P 536014

A REPAIR

ON-SITE SEWAGE HOLDING TANK SYSTEM HOWARD COUNTY HEALTH DEPARTMENT BUREAU OF ENVIRONMENTAL HEALTH

SITE ADDRESS: 12054 HALL SHOP ROAD TAX MAP: 41
PARCEL: 130

Holding Tanks

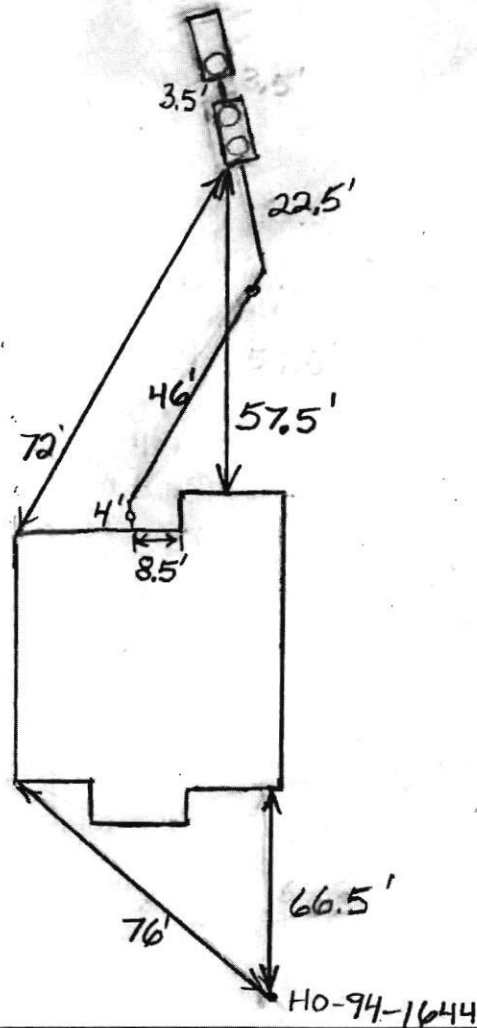
10/27/11 Set tanks min 20' from dwelling. Keep 100' removed from ex. well. Tanks must be watertight tested. w/ a manhole access on both tanks. Contractor understands the set up of alarms on both tanks. (KW)

11/2/2011 Tank holes dug. Tanks moved farther away from house than originally planned. Original location has full trenches. (BB)
 11/3/2011 Tanks set. Need to make house connection. (BB)
 11/4/2011 House connection made. Need alarm test. (BB)
 11/17/2011 Alarm working. Contractor supplied letter from Mayer Bros. stating that both tanks were water tested and passed. (BB)
